PHASE 1 SITE PLAN

MARKETPLACE AT EL PASEO

HERNDON AVENUE AND BRYAN AVENUE
FRESNO, CALIFORNIA

A1.11

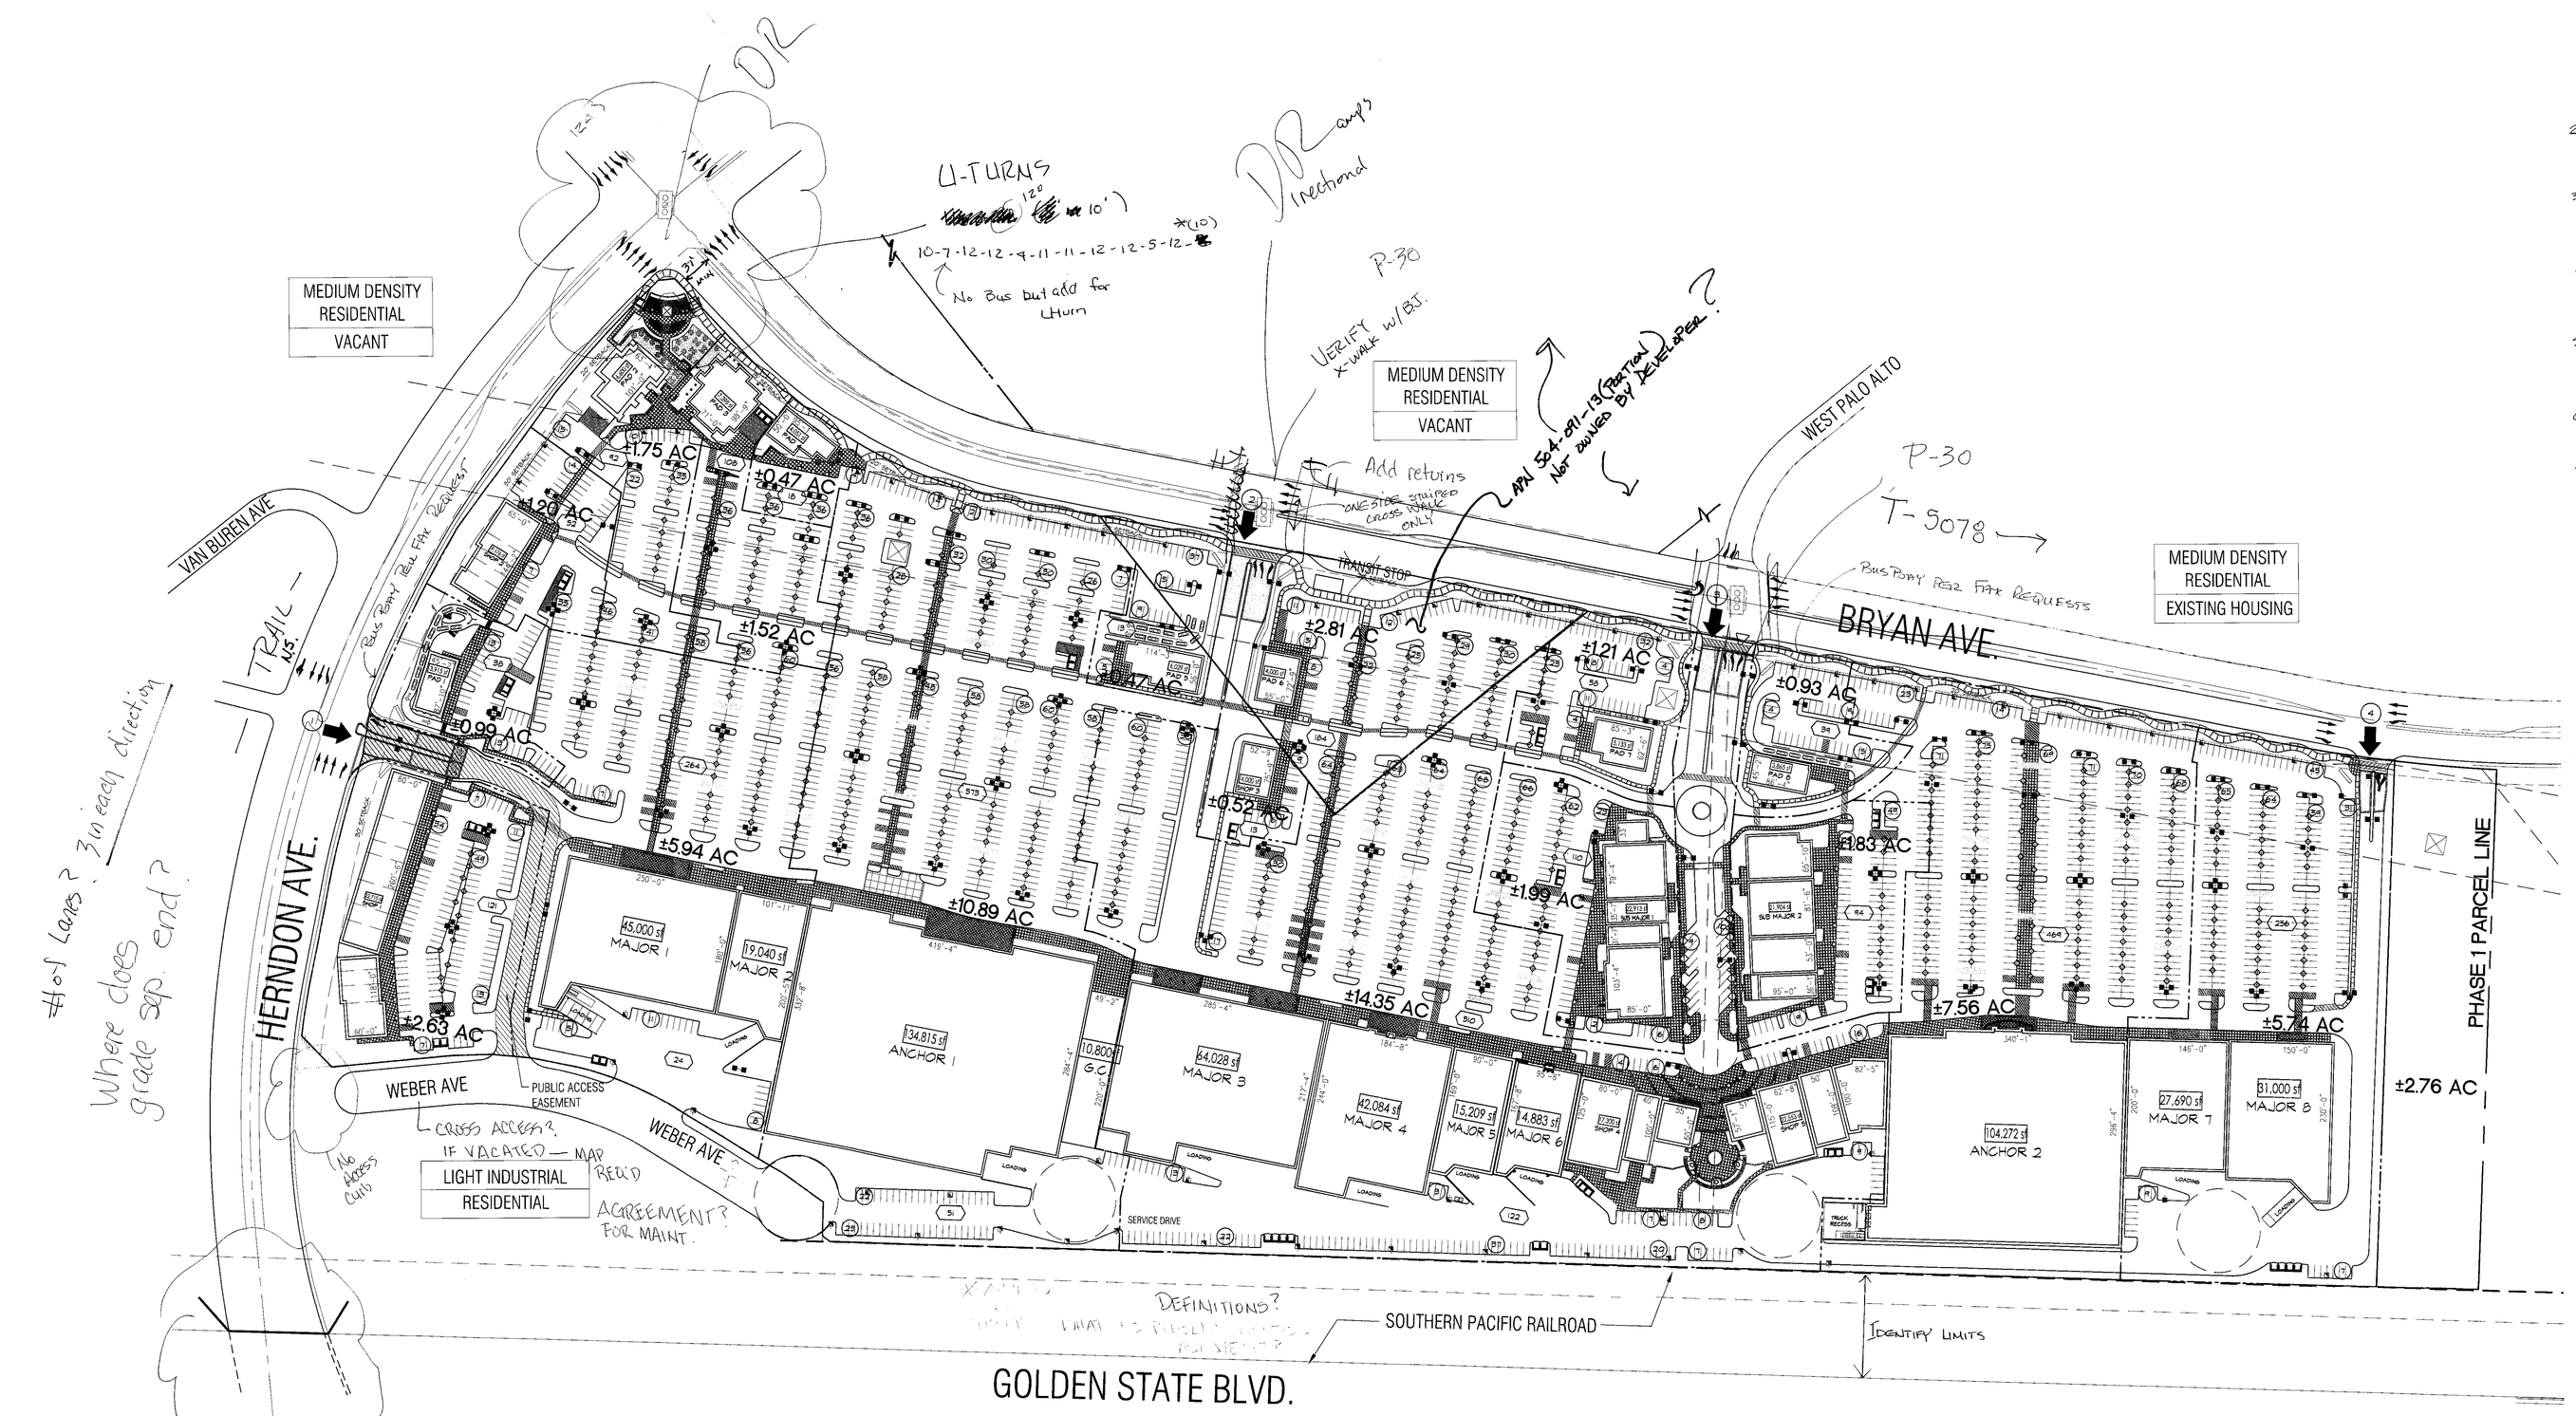
ADD NOTES:

1. ANY SURVEY MONUMENTS WITHIN THE AREA OF CONSTRUCTION SHALL BE PRESERVED OR RESET BY A PERSON LICENSED TO PRACTICE LAND SURVEYING IN THE STATE OF CALIFORNIA.

2. REPAIR ALL DAMAGED AND/OR OFF-GRADE CONCRETE STREET IMPROVEMENTS, AS DETERMINED BY THE CONSTRUCTION MANAGEMENT ENGINEER, PRIOR TO OCCUPANCY.
3. 2 WORKING DAYS BEFORE COMMENCING EXCAVATION OPERATIONS WITHIN THE STREET RIGHT-OF-WAY AND/OR UTILITY EASEMENTS, ALL EXISTING UNDERGROUND FACILITIES SHALL HAVE BEEN LOCATED BY UNDERGROUND SERVICES ALERT (USA). CALL 1-800-642-2444

4. UNDERGROUND ALL EXISTING OFF-SITE OVERHEAD UTILITIES WITHIN THE LIMITS OF THIS APPLICATION AS PER FMC SECTION 12-1011 AND RESOLUTION NO. 78-522/88229.

5. DEED(S) OF EASEMENT(S) FOR THE REQUIRED DEDICATION(S) SHALL BE PREPARED BY THE OWNER/DEVELOPER'S ENGINEER AND SUBMITTED TO THE CITY WITH VERIFICATION OF OWNERSHIP PRIOR TO ISSUANCE OF BUILDING PERMITS.

6. CONTACT PUBLIC WORKS DEPARTMENT, TRAFFIC ENGINEERING @ 621-8800. 10 WORKING DAYS PRIOR TO ANY OFF-SITE CONCRETE CONSTRUCTION.
7. SUBMIT ENGINEERED STREET CONSTRUCTION PLANS TO PUBLIC WORKS DEPARTMENT, ENGINEERING SERVICES

8. SUBMIT STREET LIGHTING PLANS TO PUBLIC WORKS DEPARTMENT, TRAFFIC ENGINEERING
9. ALL IMPROVEMENTS SHALL BE CONSTRUCTED IN ACCORDANCE WITH THE STANDARD SPECIFICATIONS OF THE CITY OF FRESNO PUBLIC WORKS DEPARTMENT OR STREET CONSTRUCTION PLANS AS REQUIRED AND APPROVED BY THE CITY ENGINEER. THE PERFORMANCE OF ANY WORK WITHIN THE PUBLIC STREET RIGHT-OF-WAY (INCLUDING PEDESTRIAN AND UTILITY EASEMENTS) REQUIRES A STREET WORK PERMIT PRIOR TO COMMENCEMENT OF WORK. ALL REQUIRED STREET IMPROVEMENTS MUST BE COMPLETED AND ACCEPTED BY THE CITY PRIOR TO OCCUPANCY.

10. ANY UTILITIES REQUIRING RELOCATION SHALL BE THE RESPONSIBILITY AND AT THE EXPENSE OF THE DEVELOPER; FIRE HYDRANTS WILL BE RELOCATED BY CITY FORCES. DEVELOPER IS RESPONSIBLE TO NOTIFY CITY WATER DIVISION @ 621-5300 TO ARRANGE AND COORDINATE WORK.

11. THE REQUIRED 4' MINIMUM PATH OF TRAVEL SHALL BE PROVIDED ALONG THE PUBLIC SIDEWALK DIRECTLY IN FRONT OF PROPERTY, AS REQUIRED BY THE CALIFORNIA ADMINISTRATION CODE (TITLE 24). A PEDESTRIAN EASEMENT MAY BE REQUIRED IF REQUIREMENTS ARE NOT MET.

✓ Vacate weber or Alternative to be approved City + Traffic engr.

PROVIDE:

3. LEGAL DESCRIPTION

Herndon
No Bike in street
Trail opp. side

* monolithic across tracks 10' pattern 6' walk 4' from Curb face

A1.13

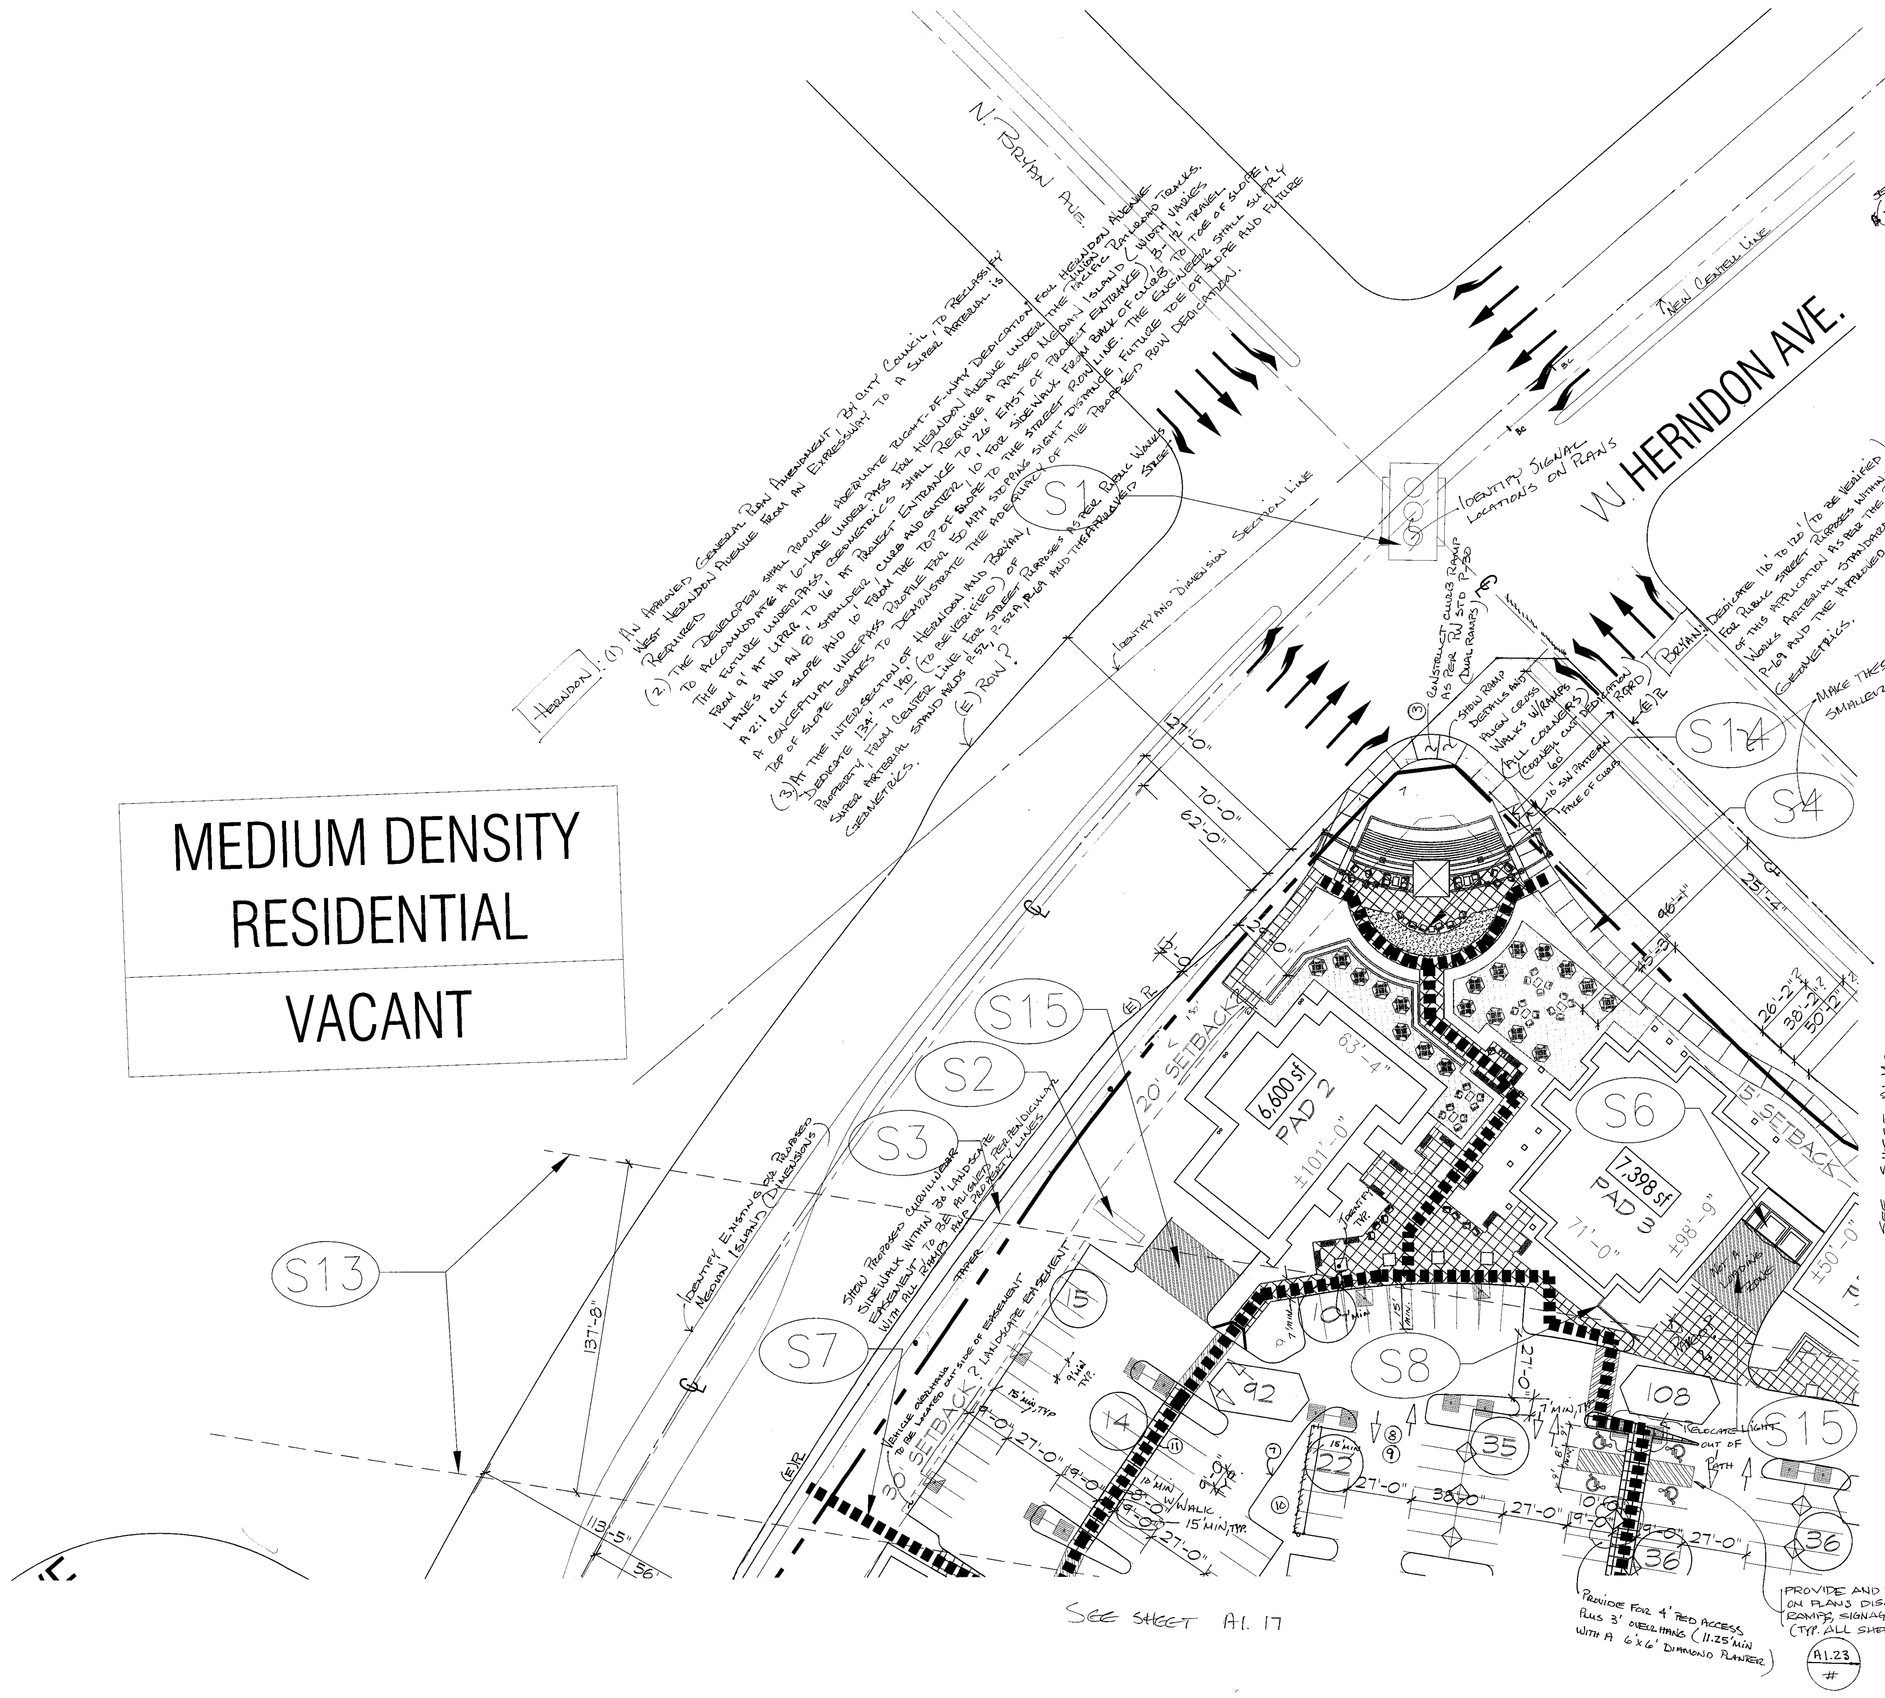
- S1 TRAFFIC SIGNAL SHOW LOCATION ON PLAN
- S2 MONUMENT SIGN, TYPICAL
- S3 ~~SIDEWALK PER STREET SECTION ADJACENT TO HERNDON.~~ SEE NOTE #2a-d
- S4 6' 10' MEANDERING SIDEWALK ADJACENT TO BRYAN
- S5 PARK & RIDE
- S6 TYPICAL TRASH ENCLOSURE AS PER CITY STANDARDS.
- S7 PEDESTRIAN PATH
- S8 6' SCREEN WALL, TYP.
- S9 TRUCK TURNING PATH
- S10 ACCENT PAVING
- S11 6' HIGH PIPE FENCE
- S12 20' SEWER EASEMENT
- S13 PG&E EASEMENT
- S14 OUTDOOR PATIO
- S15 LOADING ZONE (12' x 40' MIN) PASSENGER? OR PICK-UP/DROP-OFF — ACCESSIBLE TRUCK LOADING SPACE ONLY!
- S16 TRANSIT STOP BUS ENCLOSURE 5'x12'
- S17 DRIVE THRU WINDOW

PROVIDE AN OPERATIONAL STATEMENT FOR LOADING ZONES SHOWN NEAR PARKING STALLS. COORDINATE WITH PLANNING DEPT. AND TRAFFIC PLANNING FOR APPROVAL OF LOCATIONS

* IDENTIFY PROPOSED UTILITIES: STREET LIGHTS, SIGNAL POLE AND BOXES, FIRE HYDRANTS ETC.
* IDENTIFY BUS BAY FURNITURE
* IDENTIFY ALL EASEMENTS AND DEDICATIONS, AND VACATIONS.
* IDENTIFY AND DIMENSION EXISTING PROPERTY LINES — ON OVER ALL SITE SHEET —

ADD CONSTRUCTION NOTES: (ALL SHEETS, TYPICAL) IDENTIFY ALL PROPOSED ITEMS TO BE CONSTRUCTED

1. DESIGN AND CONSTRUCT CURB, GUTTER, 36 FT AC PAVING, AND 10 FT COMMERCIAL/~~RESIDENTIAL~~ SIDEWALK PATTERN TO PUBLIC WORKS STD. P-5.

2a. CONSTRUCT A 6' CURVILINEAR SIDEWALK AS PER FW STD. P-5 AND P-7 WITHIN THE LANDSCAPE EASEMENT ALONG SITE FRONTAGE.

(b) TRANSITION 6' CURVILINEAR SIDEWALK INTO 10' SIDEWALK PATTERN ALONG STREET, ALIGN PARALLEL 4' FROM FACE OF CURB, FROM EDGE OF PROPERTY TO THE SOUTHEAST CORNER OF GOLDEN STATE AND HERNDON.

(c) ALIGN THE 6' SIDEWALK PERPENDICULAR TO RAILROAD TRACKS AND ADJACENT TO BACK-OF-CURB.

(d) SIDEWALK SHALL LINE UP PERPENDICULAR AT ALL RAMPS AND PROPERTY LINES.

(a.) CONST. A 6' CURVILINEAR AS PER FW STD. P-5 AND P-7. SIDEWALK SHALL LINE UP PERPENDICULAR AT ALL RAMPS AND PROPERTY LINES. A DEDICATION FOR A PEDESTRIAN EASEMENT IS REQD.

3. CONSTRUCT HANDICAP RAMP PER PUBLIC WORKS STD. P-30, RADIUS = 30' (MAYVARY) DETECTABLE WARNING DEVICES ARE REQUIRED. REF: FW STD P-86 AND P-87.

4. REMOVE EXISTING IMPROVEMENTS AND INSTALL REQUIRED IMPROVEMENTS TO NEW STREET ALIGNMENT AND GRADE.

5. CONSTRUCT AN UNDERGROUND STREET LIGHTING SYSTEM AS PER PUBLIC WORKS STANDARD E-1 AND E-7. STREET LIGHTING PLANS ARE REQUIRED AND MUST BE APPROVED BY THE PUBLIC WORKS DEPARTMENT/ TRAFFIC ENGINEERING PRIOR TO ENCROACHMENT OF WORK.

6. DESIGN AND CONSTRUCT STREET-TYPE APPROACH TO PUBLIC WORKS STD P-77 AND AS APPROVED BY TRAFFIC ENGINEER. PROVIDE 16' RED CURBING (3 COATS) ON BOTH SIDES OF THE PROPOSED DRIVE APPROACHES.

13. CONSTRUCT BUS BAY CURB AND GUTTER AS PER FW STD P-13, COMPLETE WITH A 10' MONOLITHIC SIDEWALK. CONSTRUCT CONCRETE PAD TO ACCOMODATE ANY ADDITIONAL AREA NEED FOR BUS FURNITURE AND TO COMPLY WITH ADA ACCESS REQUIREMENTS. PED EASEMENT REQUIRED FOR PUBLIC ACCESS, IF LIMITS EXTEND BEYOND 10' PATTERN. ETC.

* COORDINATE WITH PUBLIC WORKS AND FAX FOR APPROVED LOCATIONS.

14. INSTALL 30" STATE STANDARD "STOP" SIGN(S) AT LOCATION(S) SHOWN. SIGN SHALL BE MOUNTED ON A 2" GALVANIZED POST WITH THE BOTTOM OF THE SIGN 7' ABOVE GROUND. LOCATED BEHIND CURB AND IMMEDIATELY BEHIND MAJOR STREET SIDEWALK. A "RIGHT TURN ONLY" SIGN IS ALSO REQUIRED AT SAME LOCATION. INSTALL 30" X 30" STATE STANDARD SIGN IMMEDIATELY BELOW THE STOP SIGN ON SAME POST.
